MVEA VOLLMER SOUTH EL PASO COUNTY, CO GRADING, EROSION, & SEDIMENT CONTROL PLAN JUNE 2021

MVEA VOLLMER SOUTH	GRADING, EROSION, & SEDIMENT CONTROL PLAN
COVER SHEET	COVER SHEET
DESIGNED BY <u>JF</u>	
DRAWN BY <u>JF</u>	
CHECKED BY <u>LD</u>	
H-SCALE AS SHOWN	
V-SCALE NA	
JOB NO. 2105.00	
DATE ISSUED 6/1/21	
SHEET NO. 1 OF 7

MVEA VOLLMER SOUTH

GRADING, EROSION, & SEDIMENT CONTROL PLAN

MVEA VOLLMER SOUTH
GRADING, EROSION, & SEDIMENT CONTROL PLAN
SITE MAP

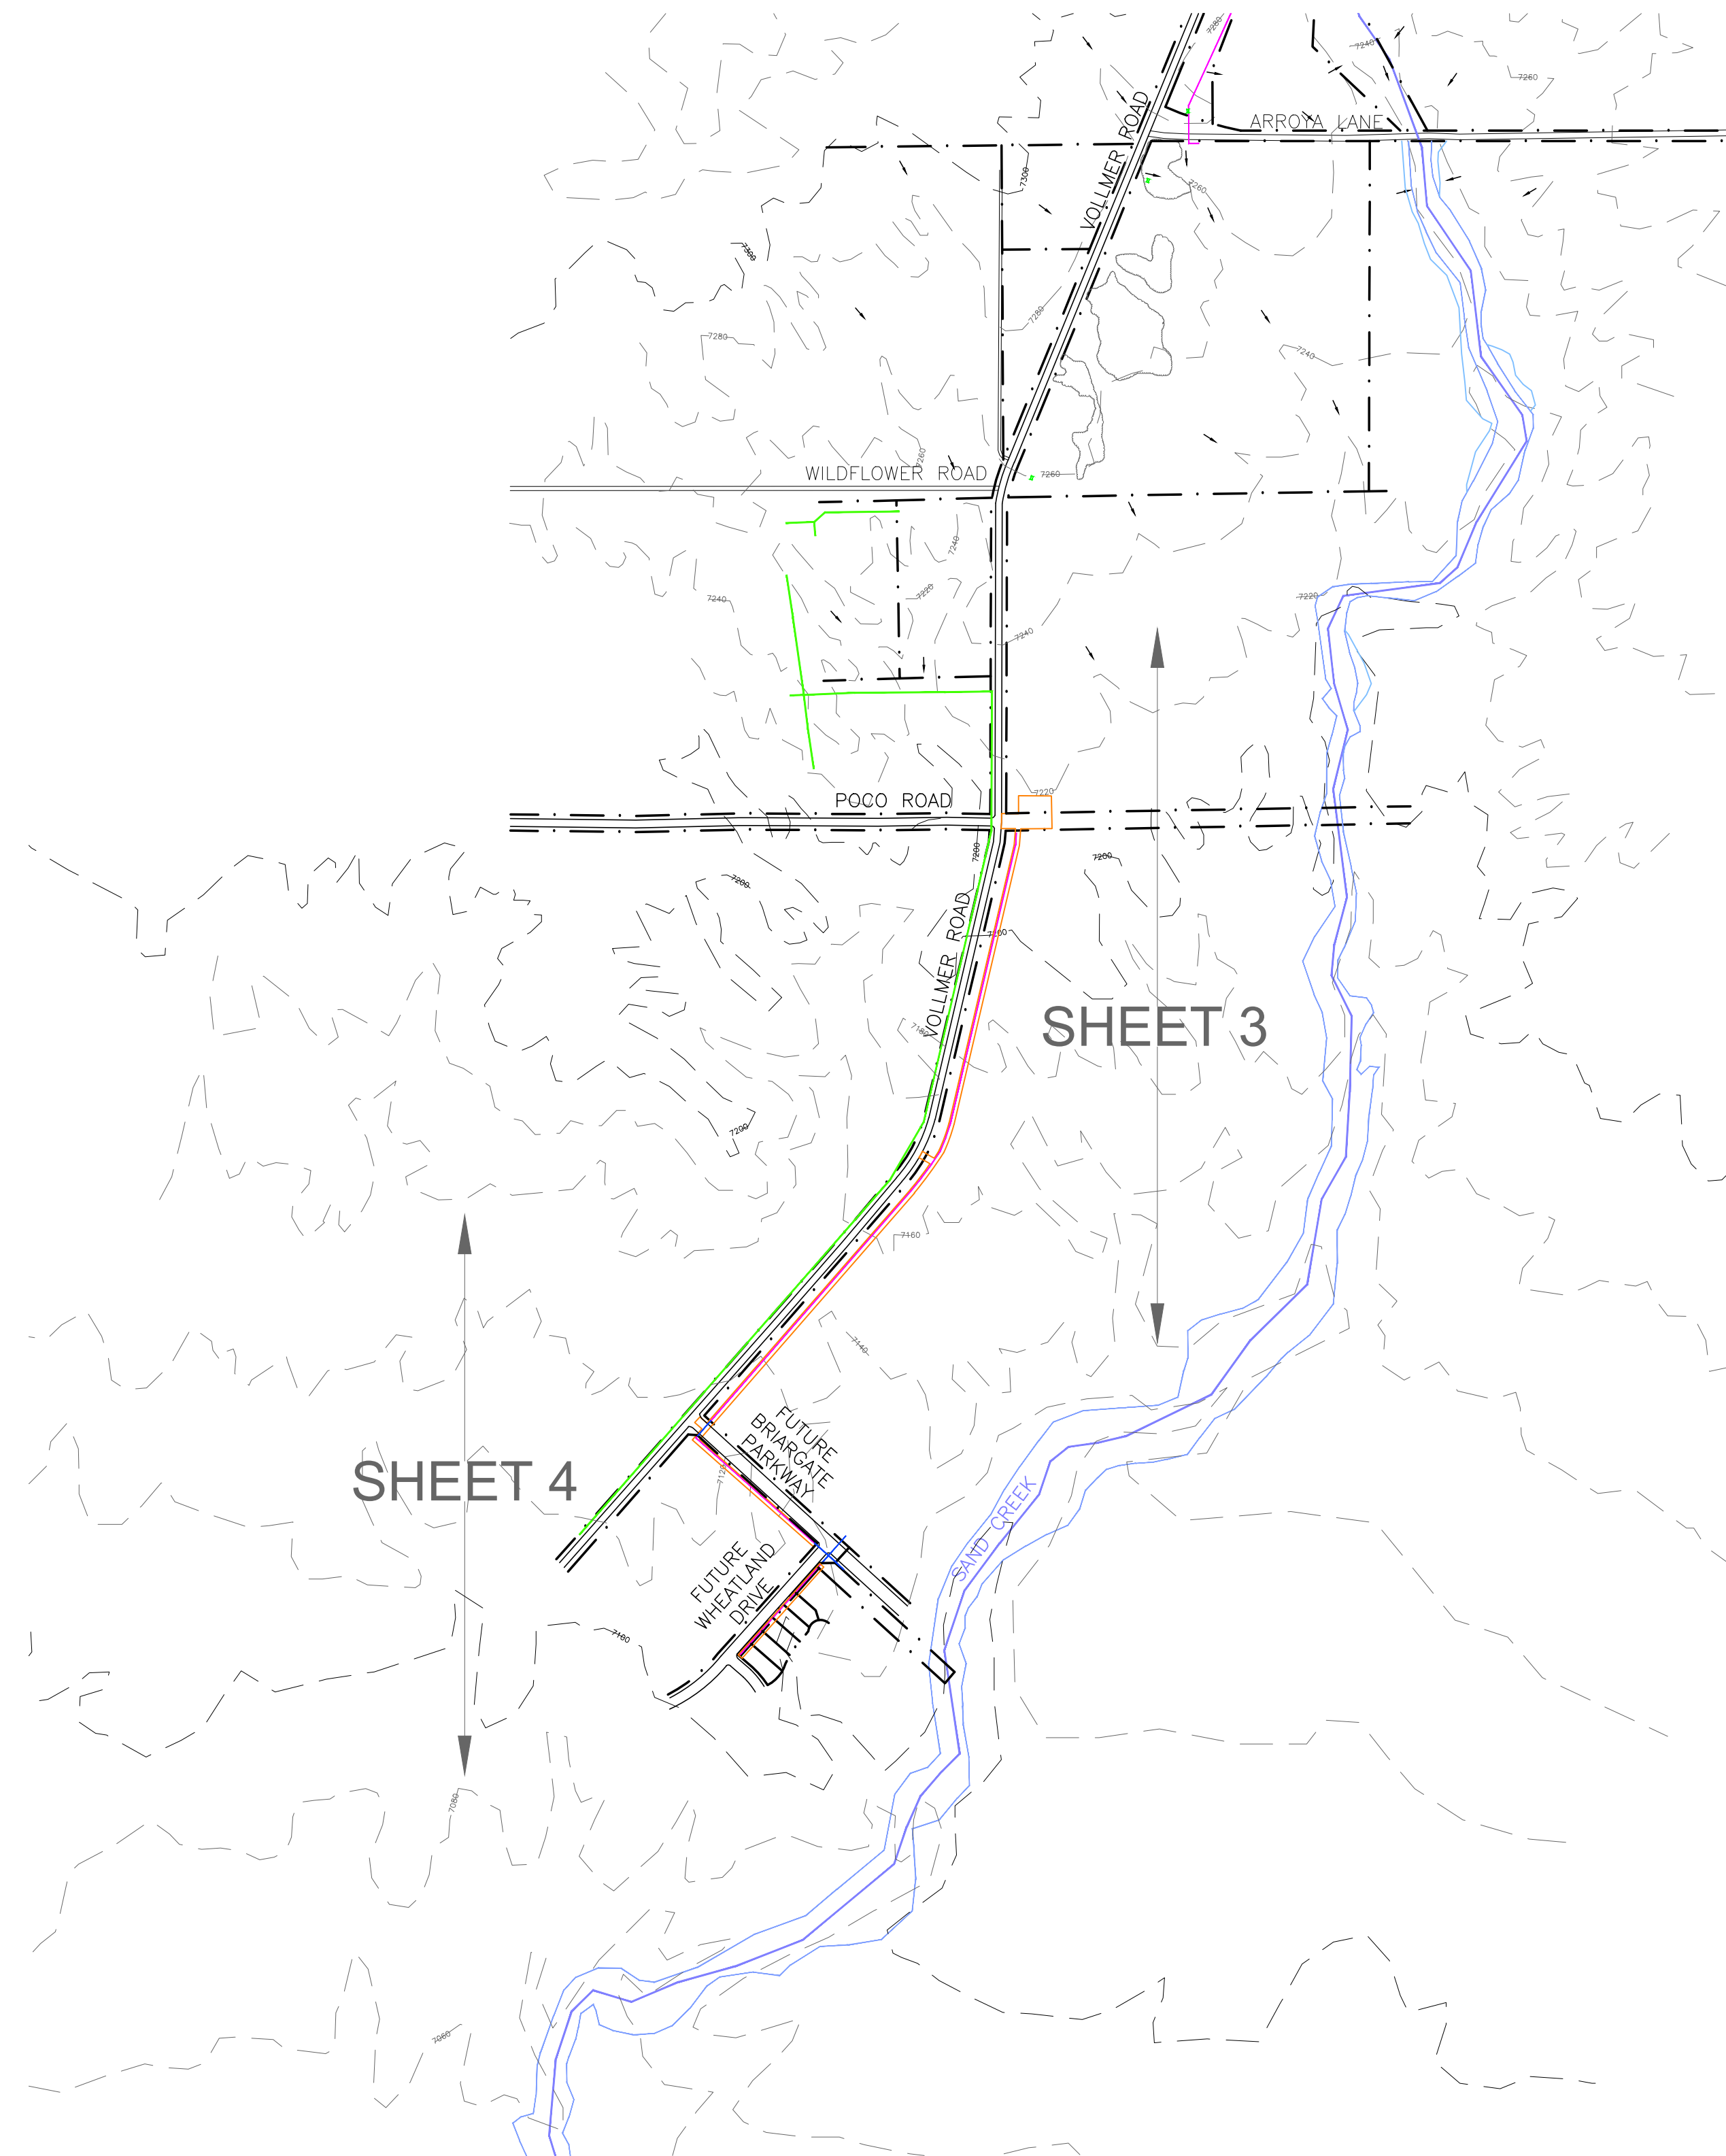
Please label all public right-of-way on all sheets.

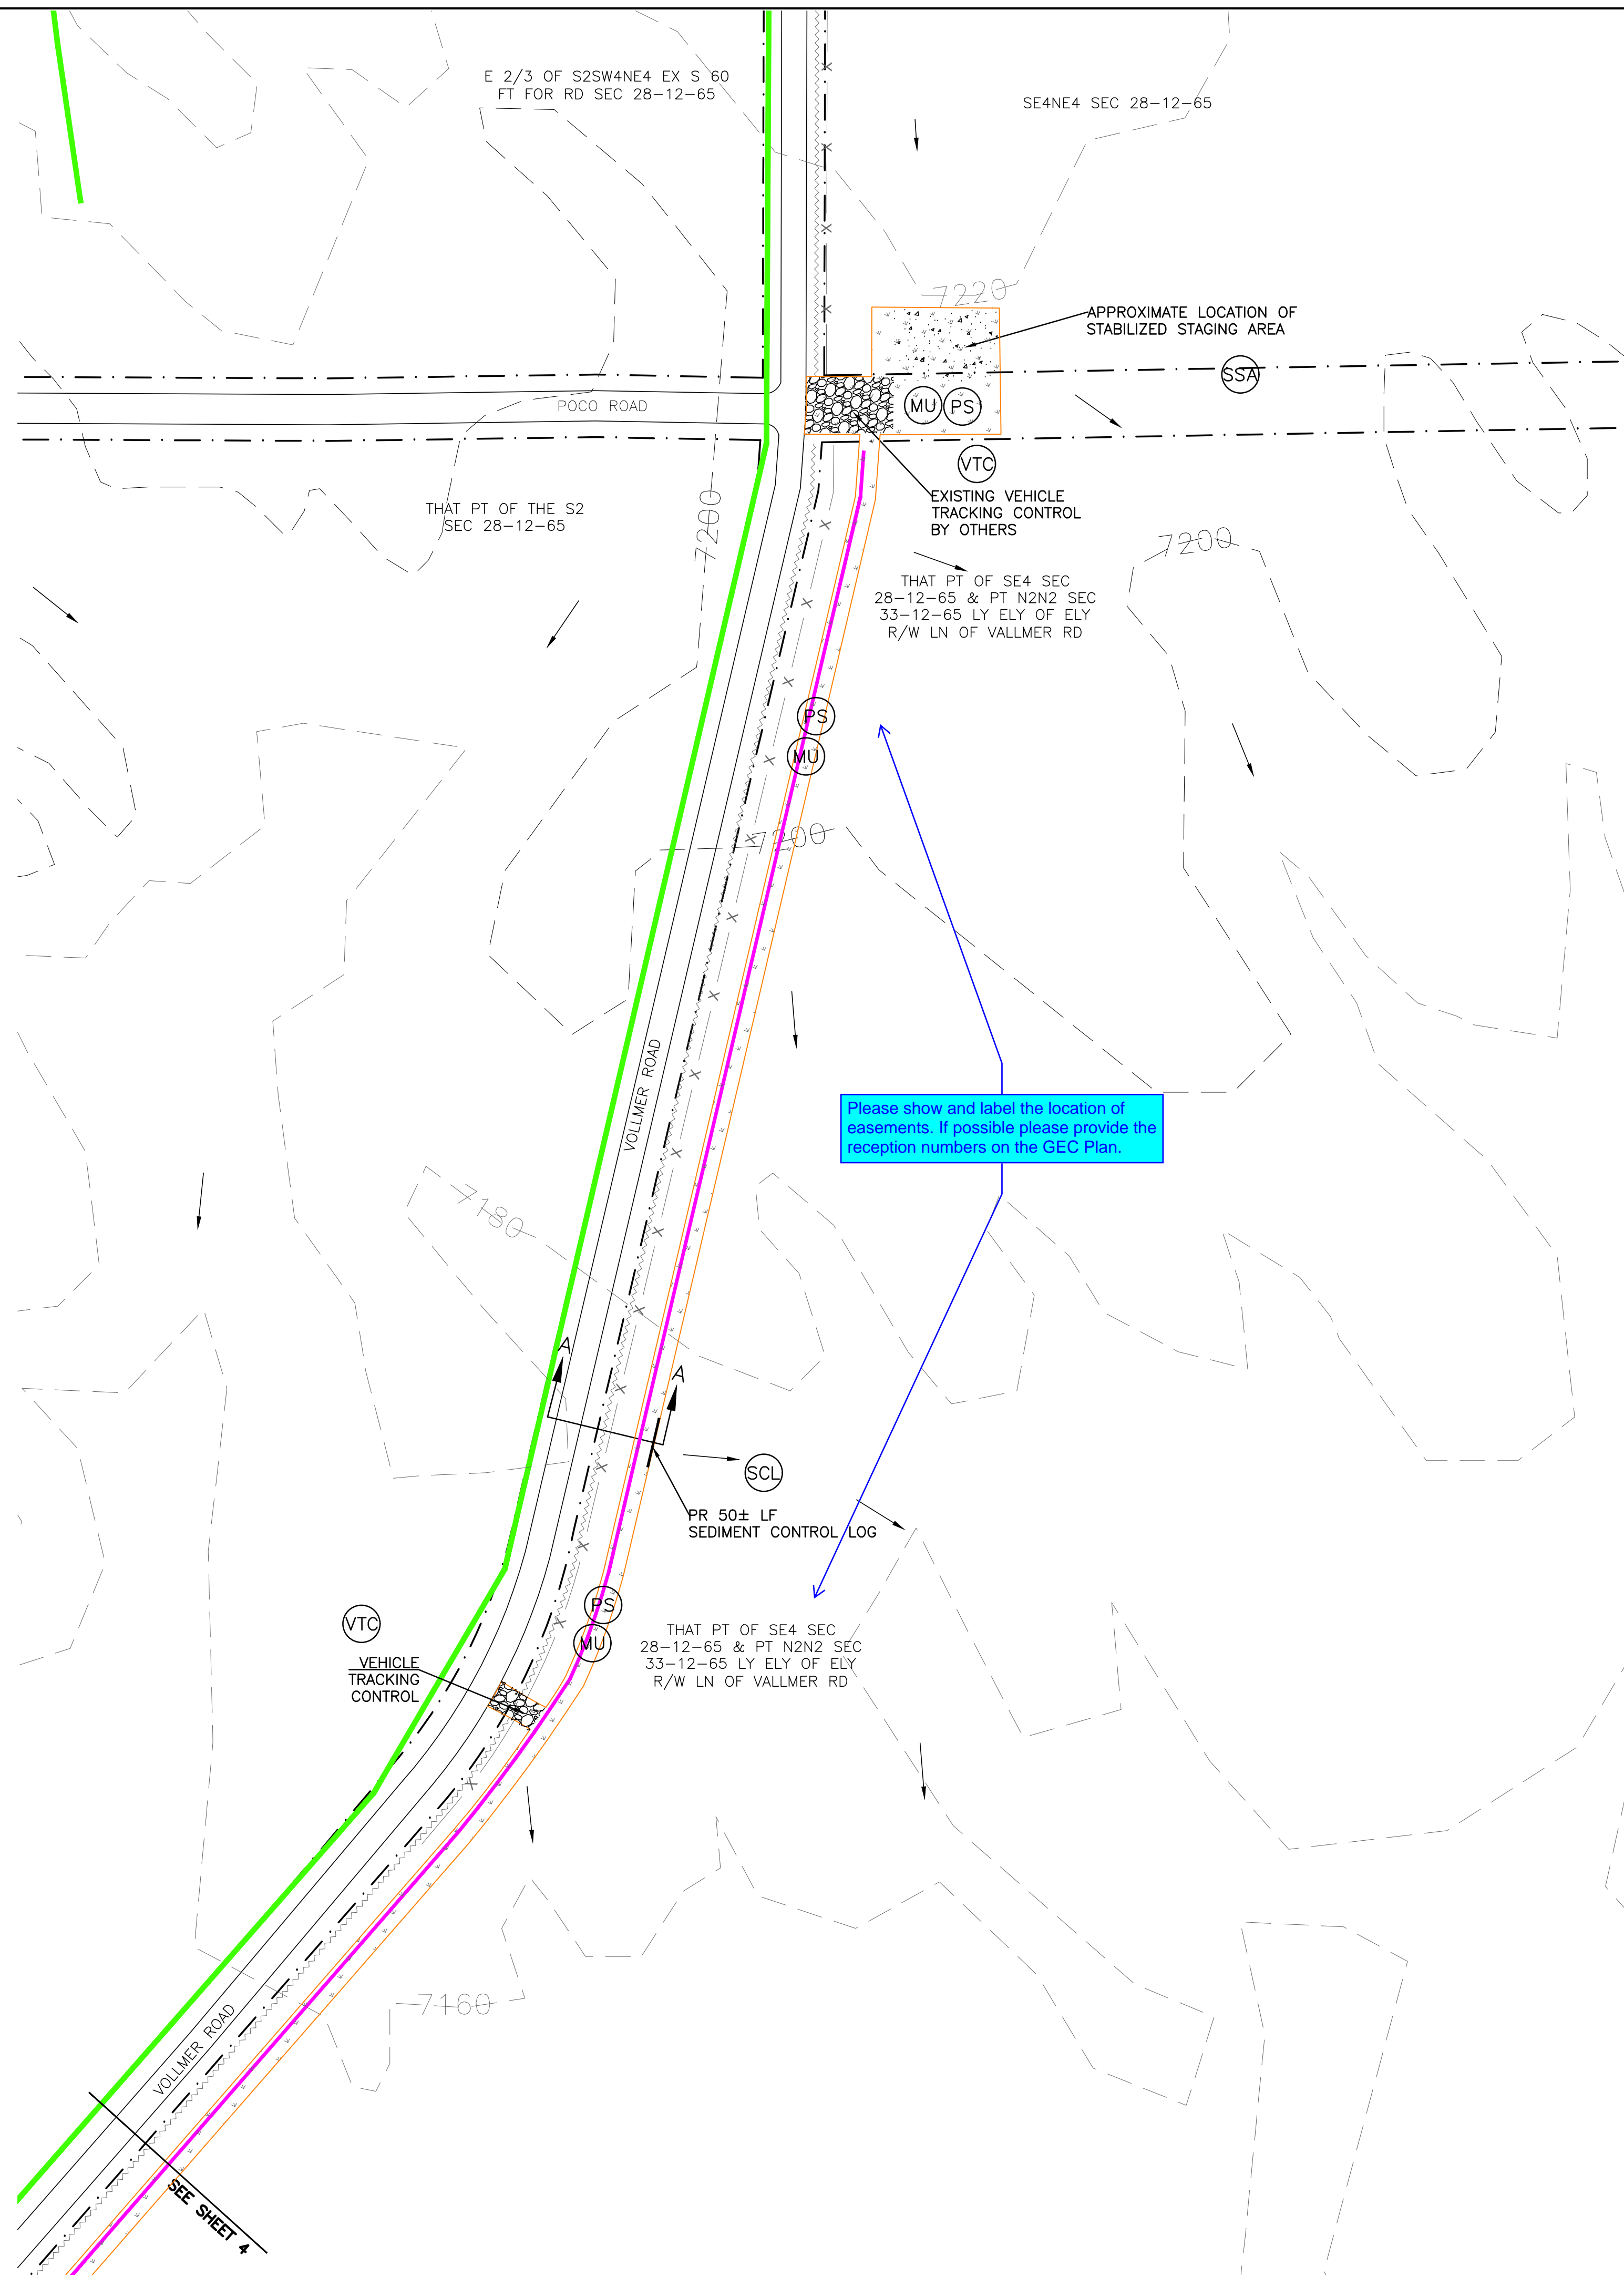
Please show and label the location of easements. If possible please provide the reception numbers on the GEC Plan.
